Proposed Revisions to a Standard Plans Index

Index Number: 700-030

Index Title: WIND AND HANGER BEAMS FOR OVERHEAD
SIGNS

FRONT ELEVATION

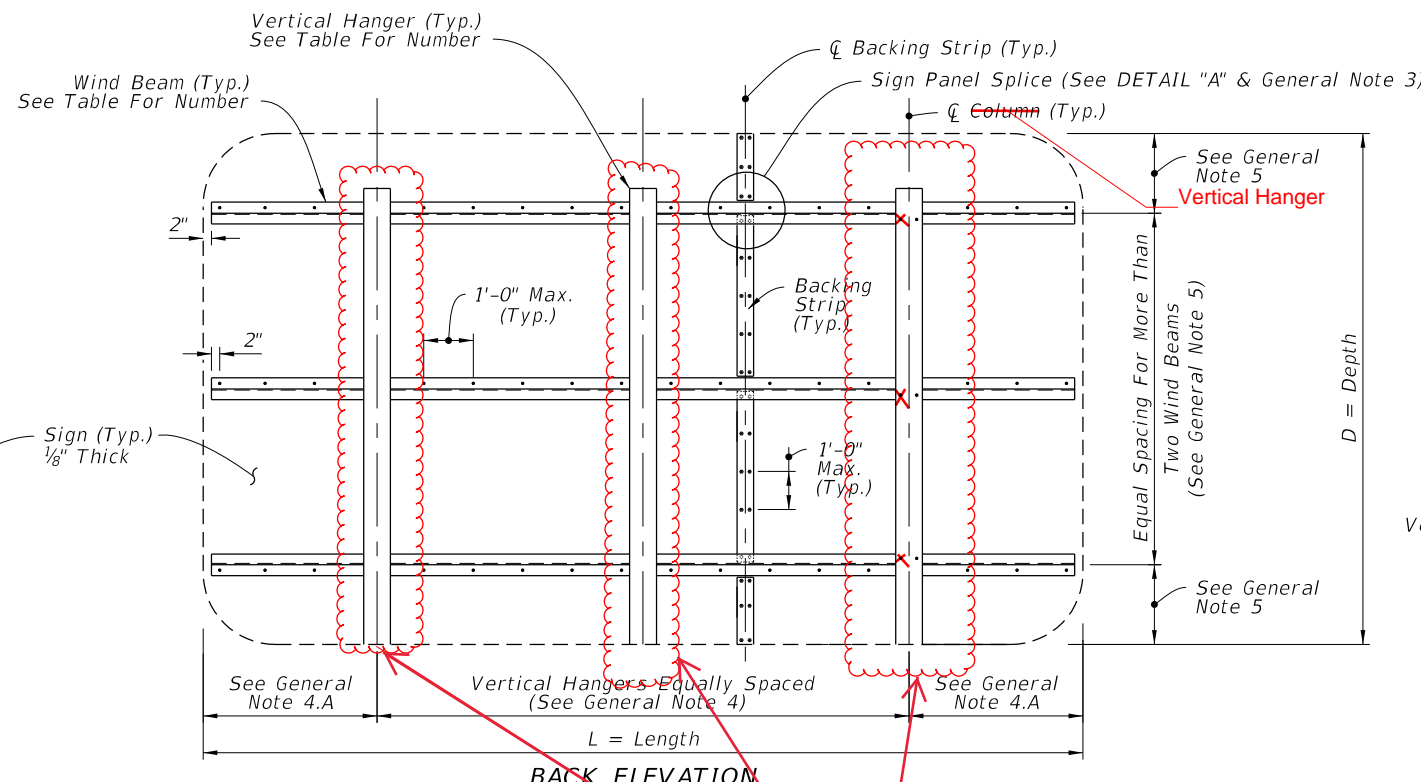
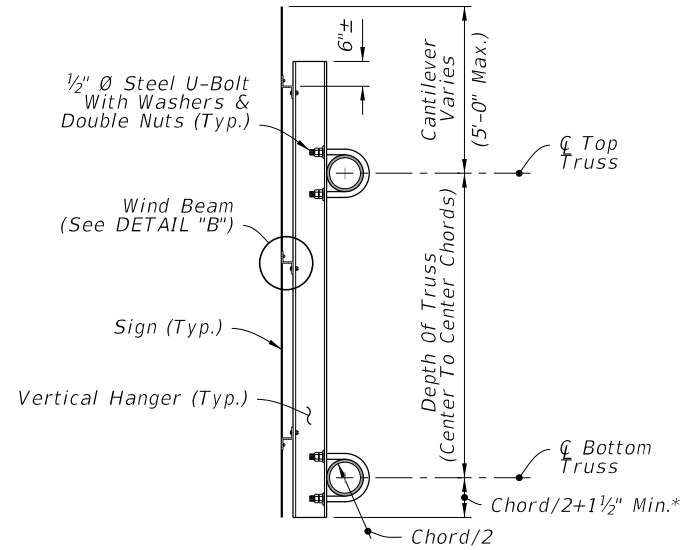
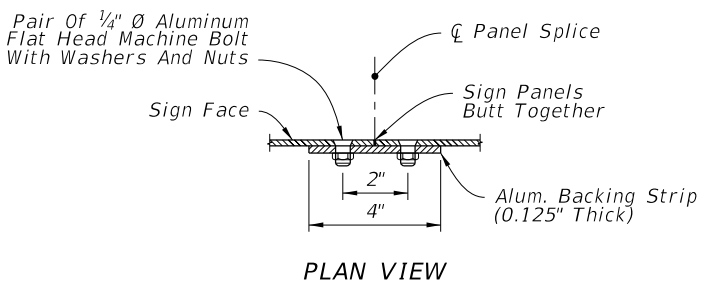
Sheet 1: Revise the bolts in the Hanger Beams to show correctly. Added language to Detail B bolt call out to clarify number of bolts required.

We received a query about the required number of bolts per intersection of the hanger beam and the wind beams. The bolts were not showing correctly in the elevation details so we corrected it.

Only show one bolt per intersection and show the bolts on the other beams as well.
